ADDENDUM # 1

Bid Number: 50-00143788

Labor, Materials, and Equipment needed to Remove and Replace Existing Flooring in the Gymnasium at The Kennedy Heights Playground

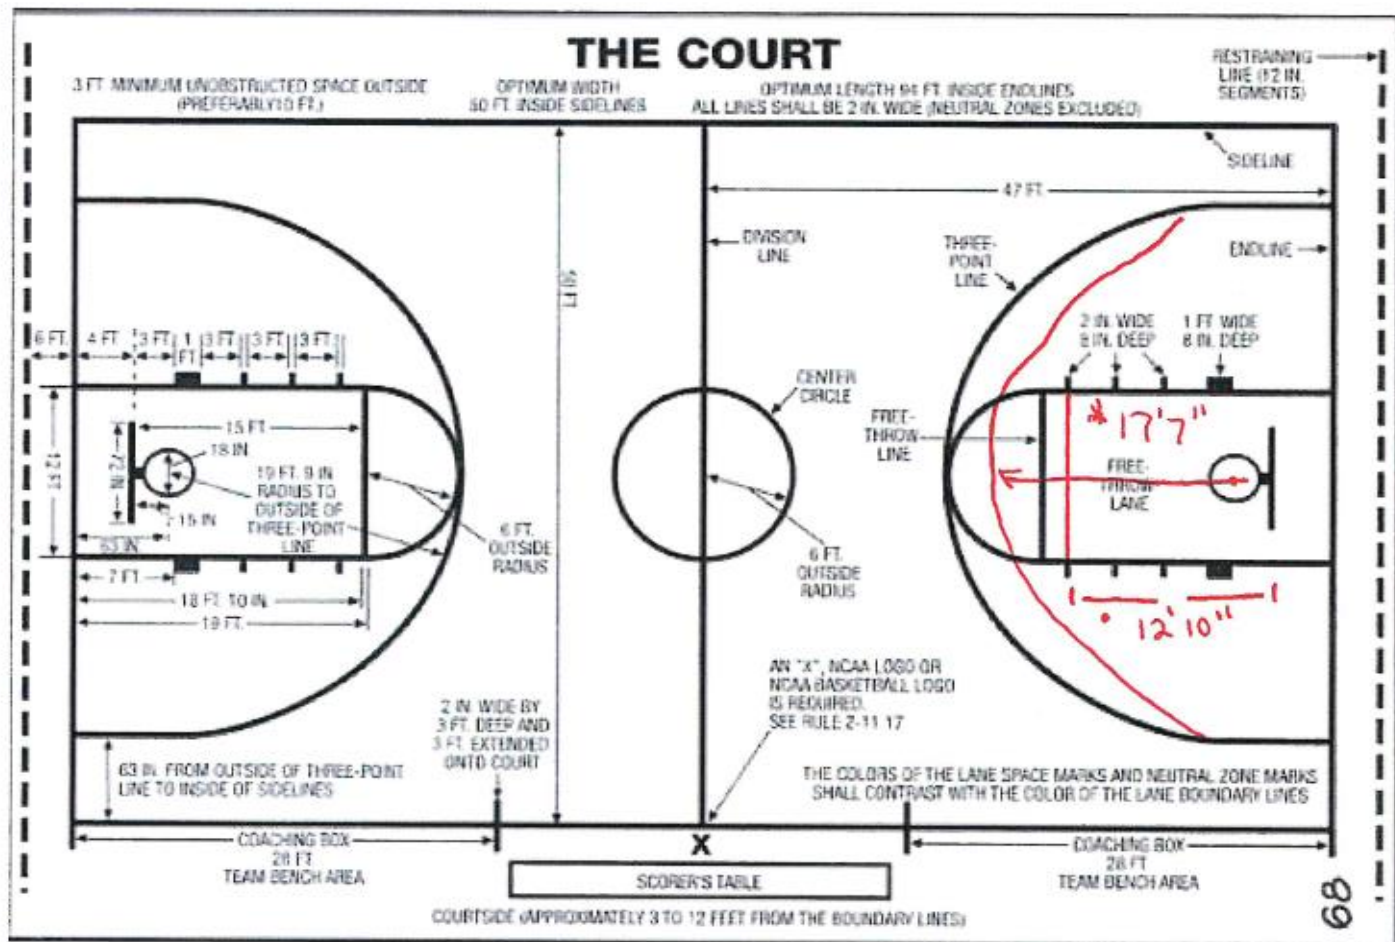
Is there a drawing preferably to scale that would reflect the details as listed within Section 6.0—Bid Specifications?

Please see attached drawing. Per the Department, this is the only drawing available, other than what was supplied in the original specifications.

- Additional Free Throw Lines and 3 point lines are to be layed down on both lanes on each side of the court.
- * 3pt. lines are to be 17'7" from the middle of the rim. (basket)
 - Free throw lines are to be 12'10" from the back board.
